State of Alaska
Department of Fish and Game
Nomination for Waters
Important to Anadromous Fish

Anadromous Water Catalog Number of Waterway **112-11-10010**

Name of Waterway **Carbon Lakes Outlet, Cascade Bay** ☒ USGS Name ☐ Local Name

☐ Addition ☒ Deletion ☐ Correction ☐ Backup Information

700
BARRIER
FALLS
SYMBOL
= Falls

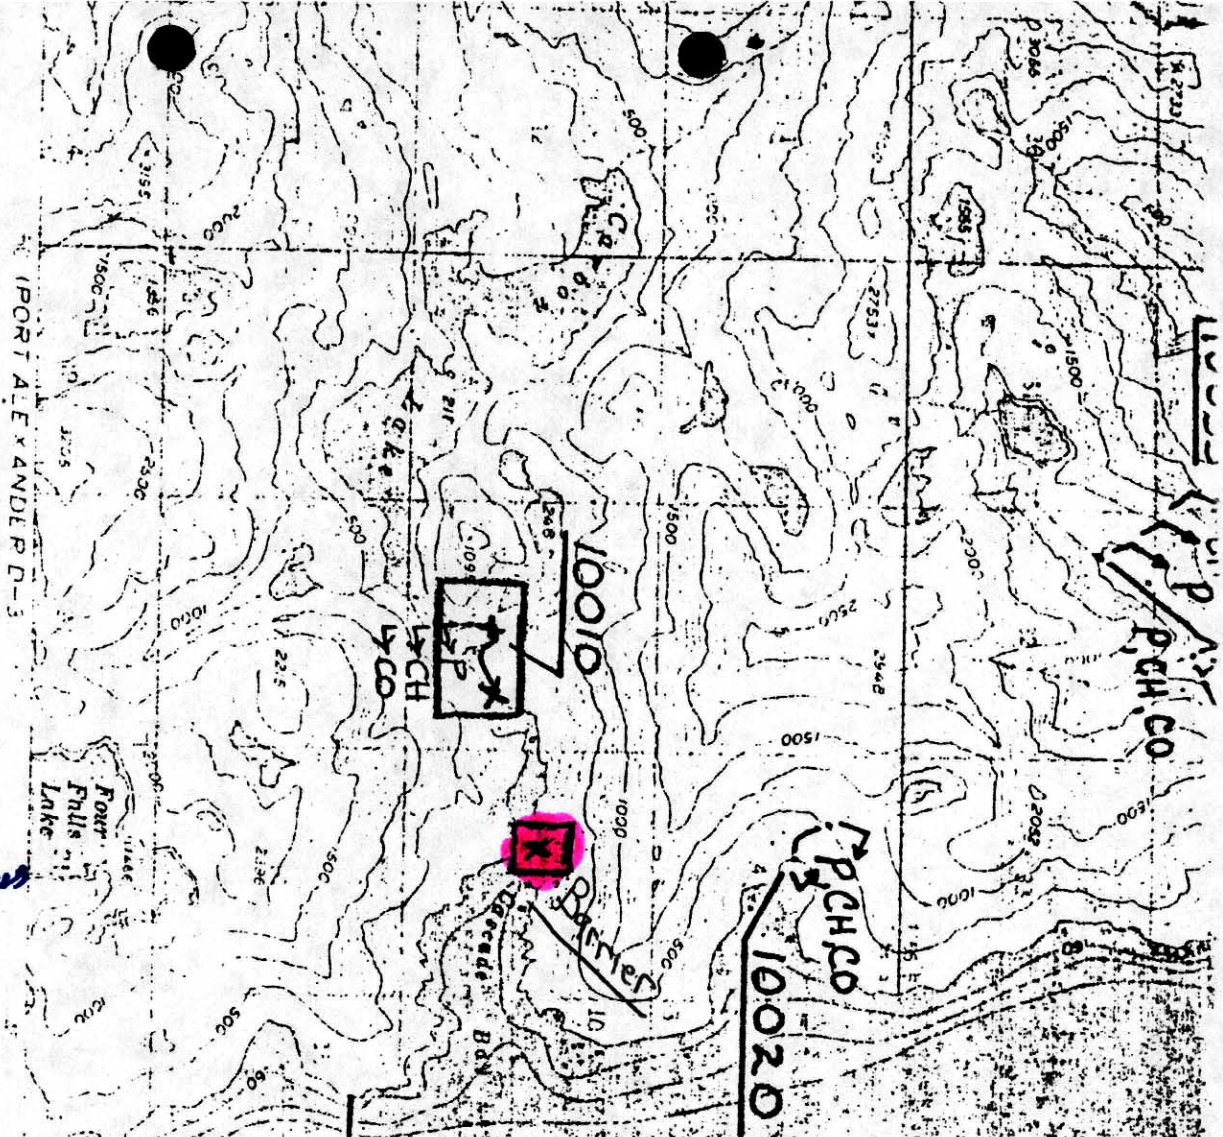
This catalogued stream has a barrier falls. The falls is listed on the USGS topo map and has been confirmed to be a barrier to anadromous fish passage by Bill Davidson (area CF biologist) Dick Crone (biologist with the NSRAA) and USFS Sitka District biologists. The habitats upstream of this falls are not used by anadromous fish.
